CH2M Beca

Wanganui WWTP – Presentation to Wanganui District Council 28 October 2015

Primary MWH Design Faults In Our Opinion

**Fig 3-12 Case 1 – 120s pathlines released from 4m depth
(17 Tornados)**

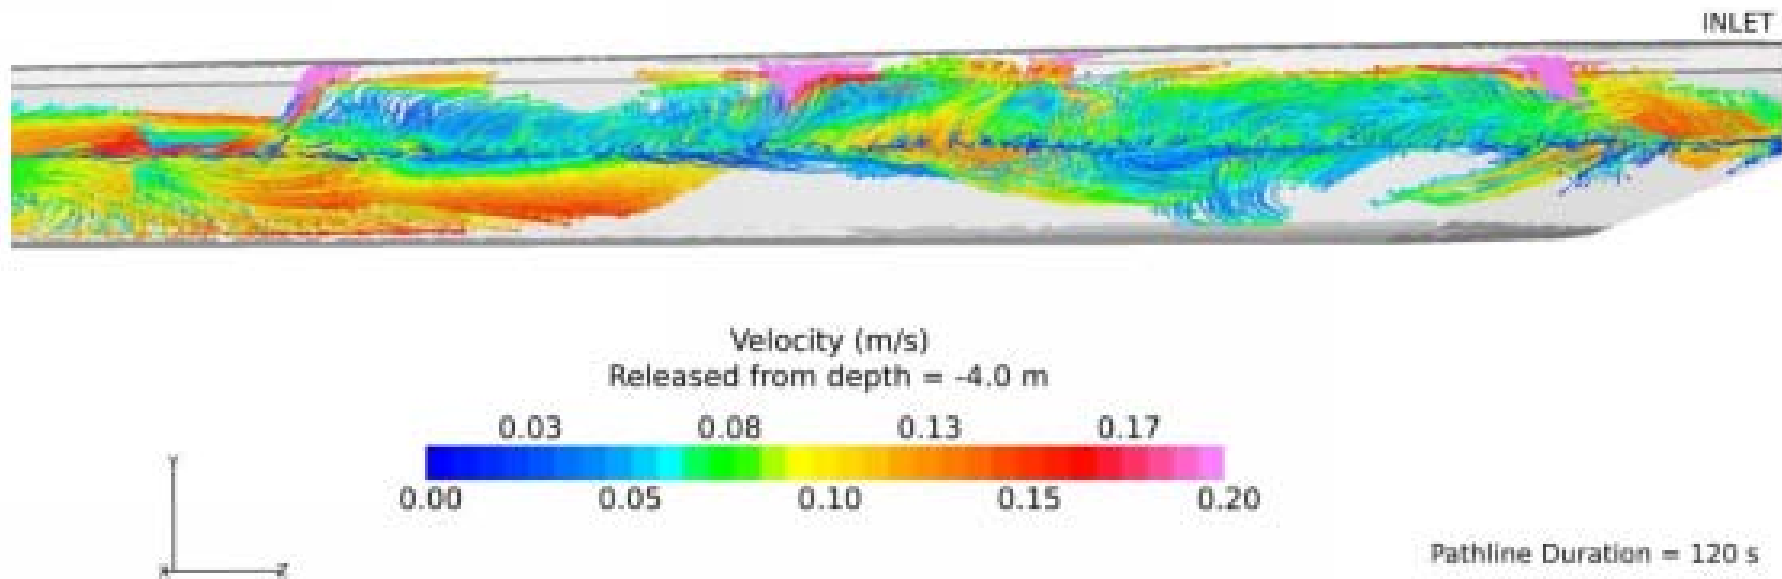
- The mixing currents from the Tornado and Twister aerators extended below the 4 m plane (interface of aerobic and anaerobic zones)
- These currents would have entrained gas-buoyed sludge and carried it into the upper aerobic zone causing increased oxygen demand, or carried oxygen into the anaerobic zone causing incomplete anaerobic digestion
- Stabilised and well-consolidated sludge may not have been entrained by the deeper currents, but as the sludge surface rose, more sludge would have been disturbed
- CFD modelling supports the guideline value for mixing energy input limit of 2 W/m^3

Sludge Storage Conclusions

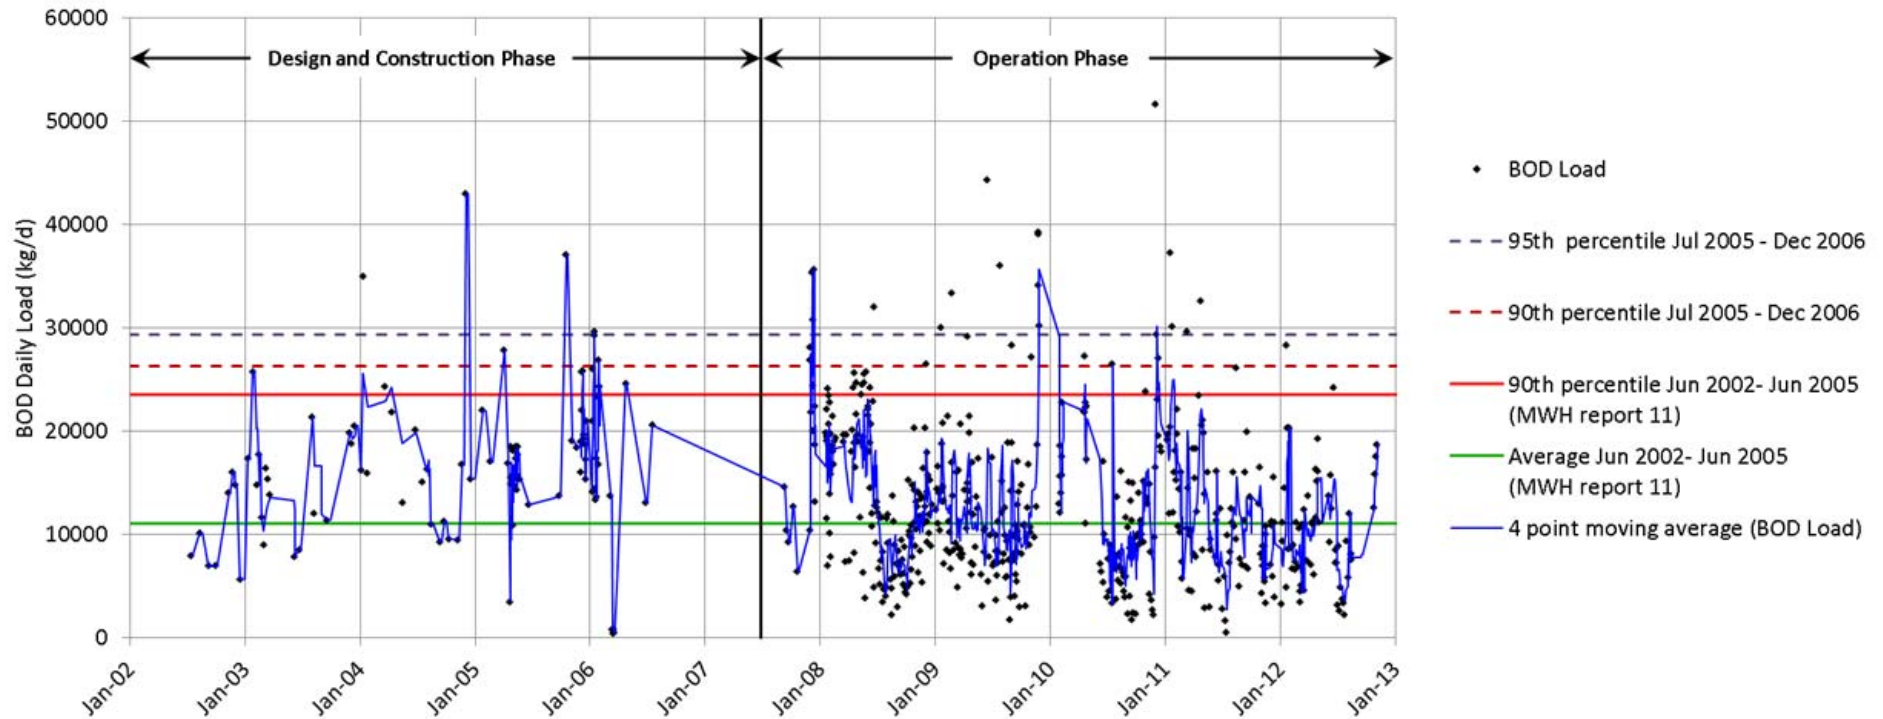
- The CH2M Beca estimate is 2 years sludge storage. The difference in estimated storage time is due to the combination of differences in the sludge mass load and the sludge consolidation factor
- MWH internal review recommendations were:
 - Loughran (MWH) estimated a significantly greater mass of solids – 4,627 Kg/d compared to 2,496 Kg/d in MWH Report 11
 - Loughran (MWH) recommended sludge consolidation to 6% or 8%, compared to 12% in MWH Report 11
 - Hoffmann (MWH) recommended sludge consolidation in the range 3% to 5%, compared to 12% in MWH Report 11
 - Report 11 does not explain why the Loughran and Hoffman recommendations were not adopted
- Also, the 2004 Peer Reviewer's concerns were not adequately addressed

Peak Season 2009/10 BOD Loads on WWTP

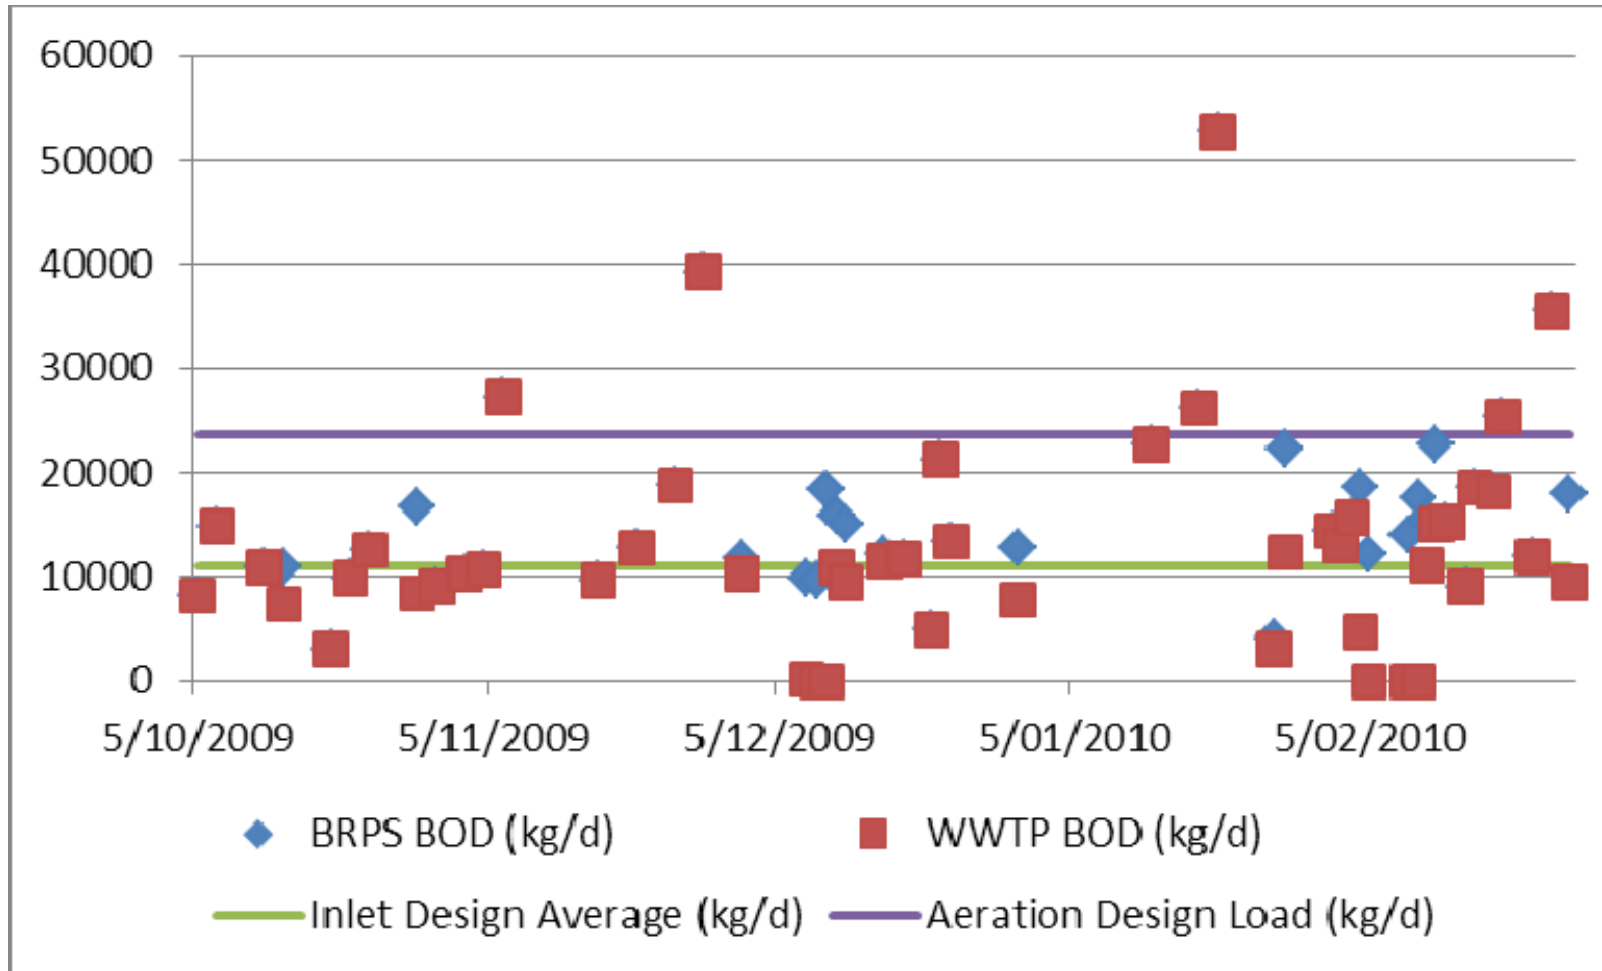
- It is expected that 1 in 10 values would be greater than the 90 percentile design load
- There are some points above the 90 percentile aeration design load in 2007/08, but few in the next few seasons.
- By using the bypass to the ocean outfall, WDC protected the plant from higher BOD loadings during peak processing seasons.
